ORIGINATION FORM

Proposed Revisions to a Standard Plans Index (Please provide all information — Incomplete forms will be returned)

Index Number: 102-600

Index Title: General Information for Traffic Control Through Work Zones

2 POST SIGN SUPPORT MOUNTING DETAILS (SINGLE POST SIMILAR) RURAL

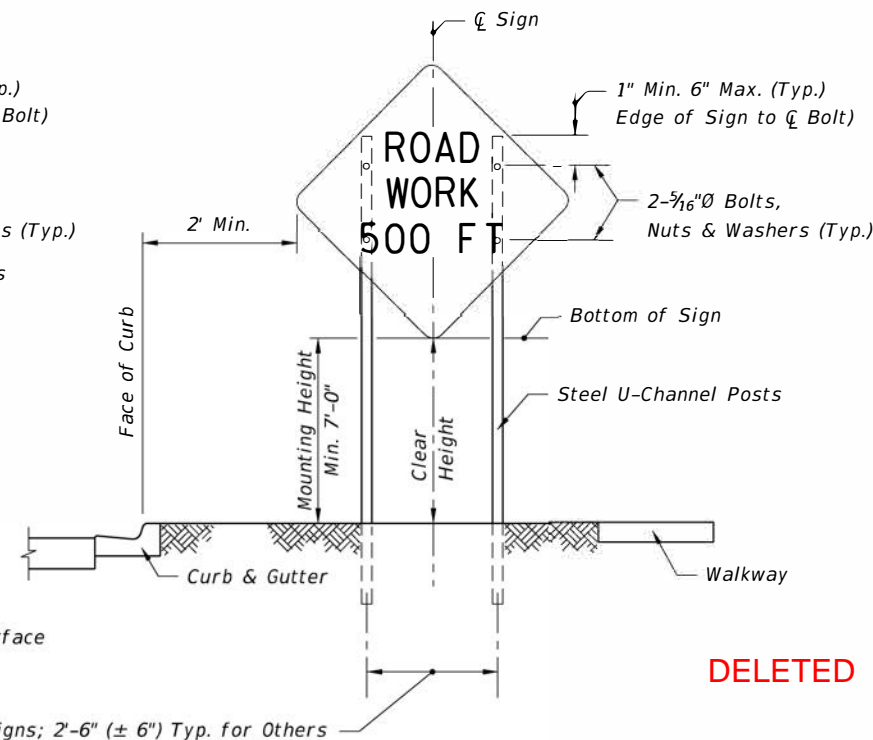
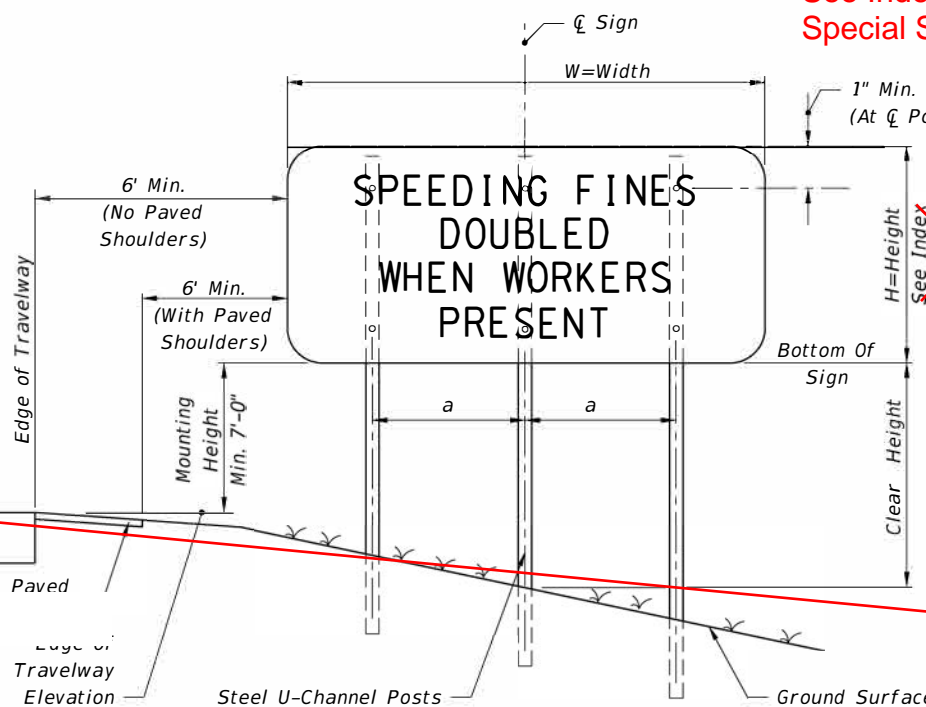
Sheet 5: Changed the Height reference note to "See Index 700-102 for Special Sign Details" and deleted the 60" Width in the 3 POST SUPPOR MOUNTING DETAILS; Moved TEMPORARY SIGN SUPPORT NOTE 9 to TABLE 7, as Note 5; Deleted the 60x64 and the 120x60* Rectangle signs and associated note from TABLE 7; Deleted "(See Note 7)" reference from the Diamond sign in TABLE 7.

3 POST SIGN SUPPORT MOUNTING DETAILS

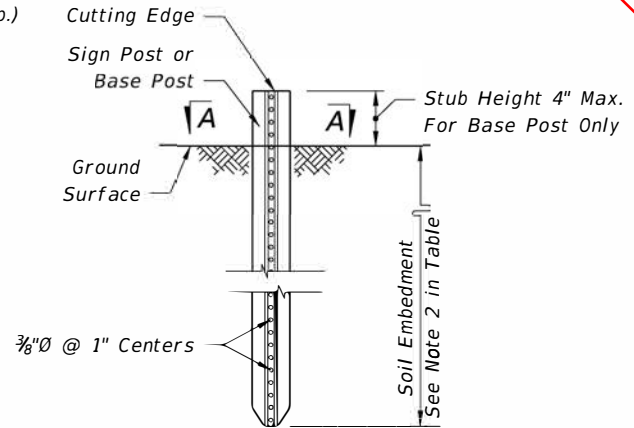
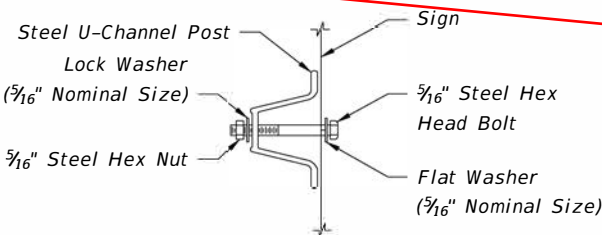
Where $W = 48"$: $a = 1' - 4\frac{1}{2}" (\pm 1")$
 ~~$W = 60"$: $a = 1' - 9" (\pm 1")$~~
 $W = 72"$: $a = 2' - 1" (\pm 1")$

DELETED

DELETED

MOVED: Note 9 as Note 5 in Table 7

Where:
 $W = 48": a = 1' - 4\frac{1}{2}" (\pm 1")$
 $W = 72": a = 2' - 1" (\pm 1")$

MANHOLES/CROSSWALKS/JOINTS

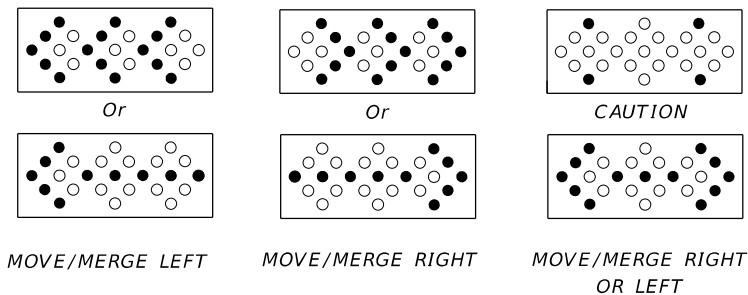
Sheet 7: Added the SIDE ROAD INTERSECTING THE WORK ZONE details form Index 102-606.

REARRANGED

**ADDED:
SIDE ROAD INTERSECTING THE WORK ZONE
detail from Index 102-606**

COMMONLY USED WARNING AND REGULATORY SIGNS IN WORK ZONES

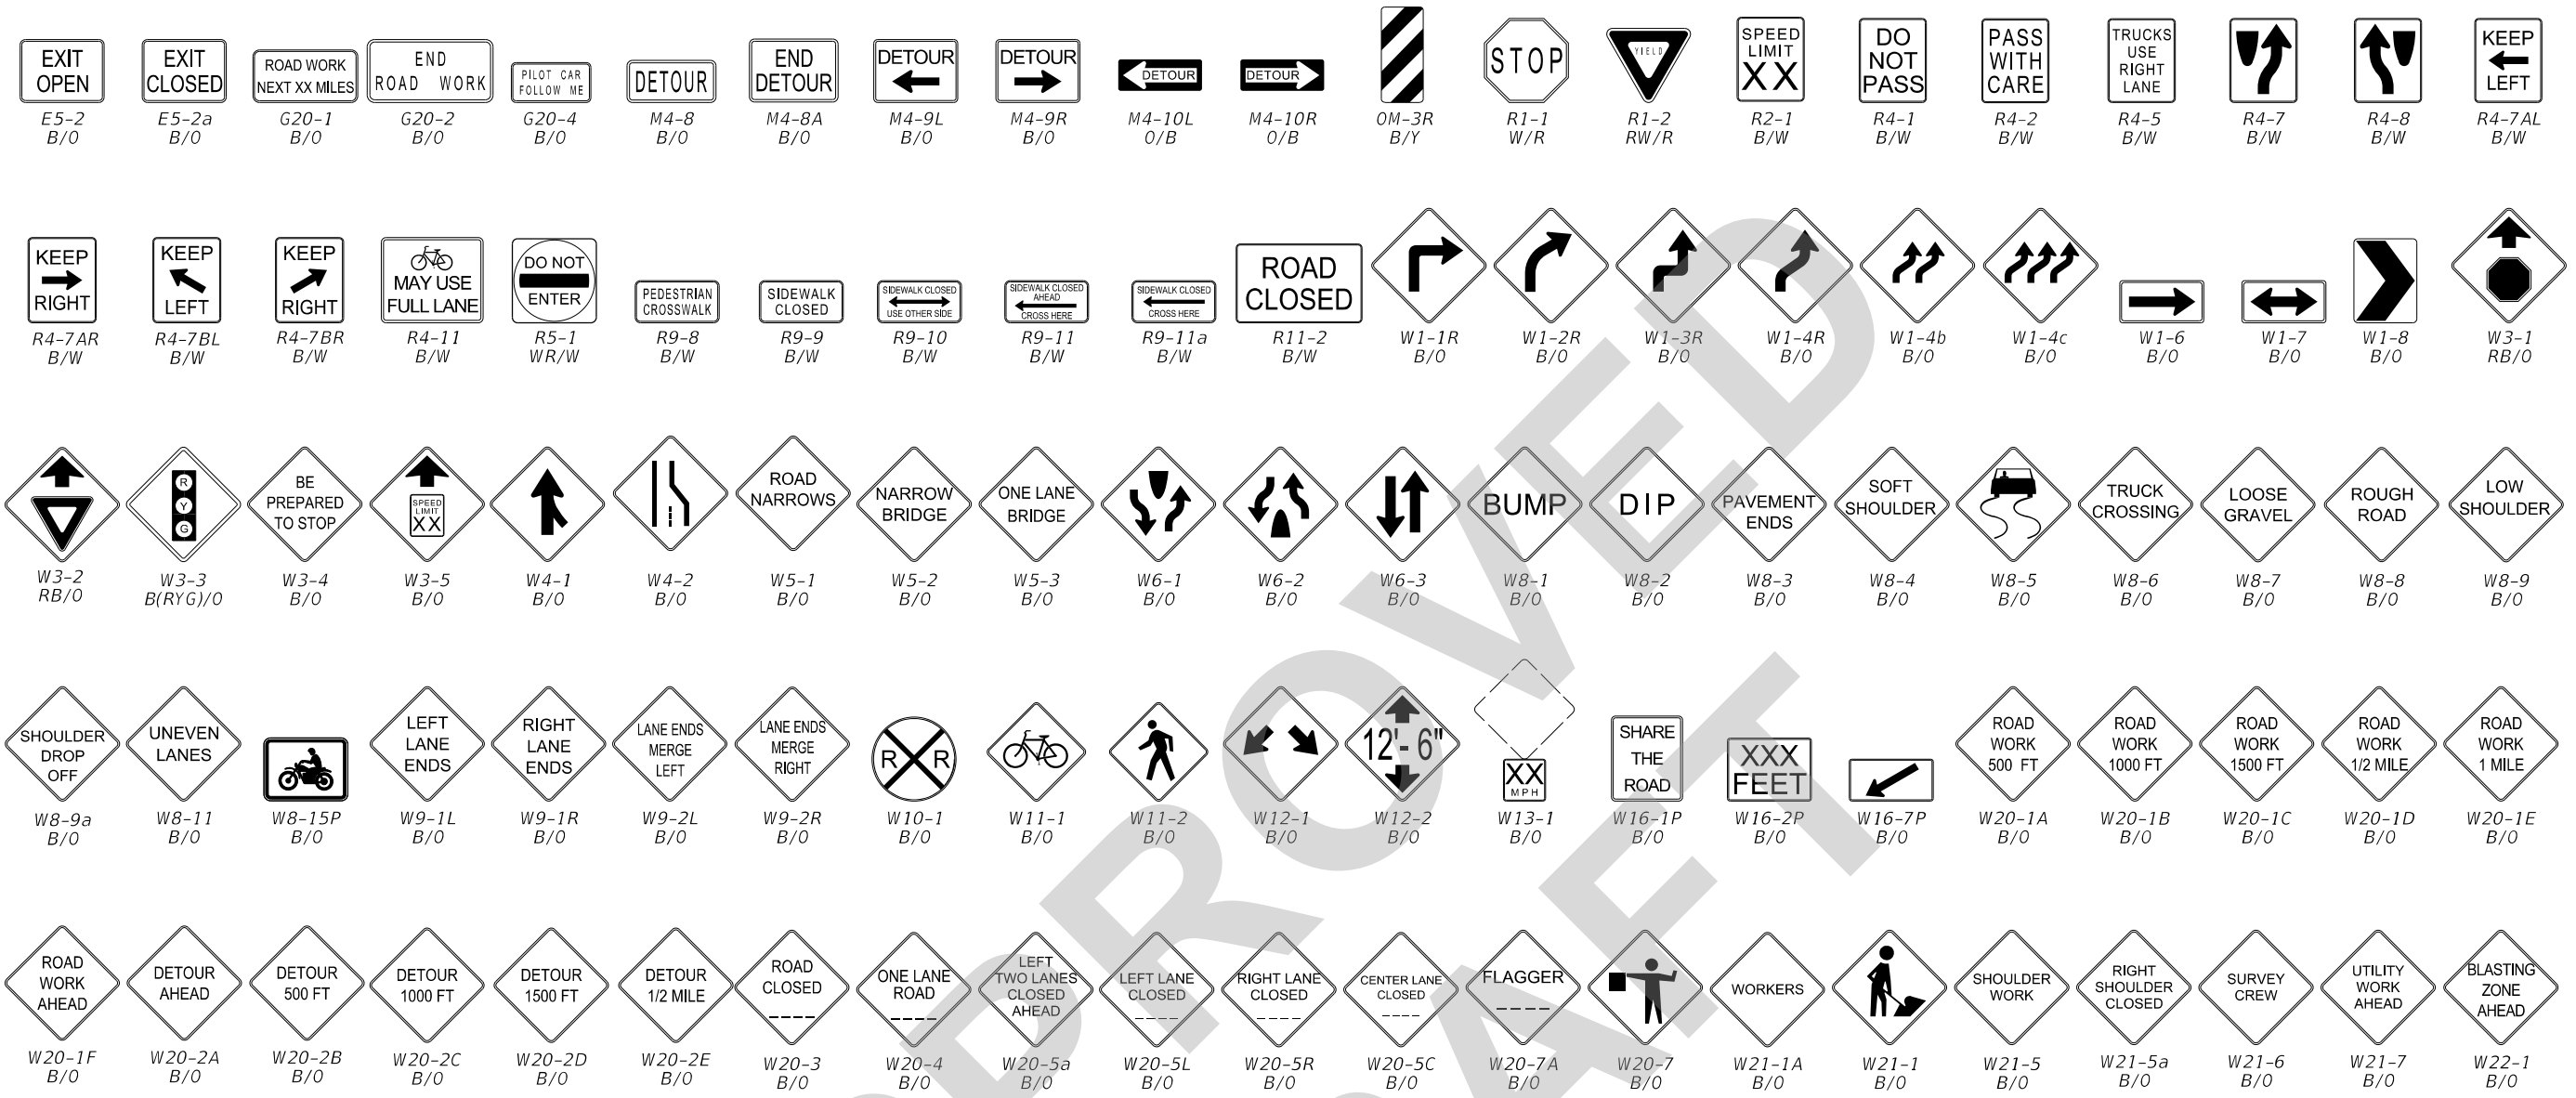
Sheet 6: Rearranged all signs: Added signs: R4-11, W11-1, and W16-1p: Deleted all of the "MOT" signs.

REARRANGED

ADDED SIGNS:
 R4-11
 W11-1
 W16-1P

DELETED ALL OF THE MOT SIGNS
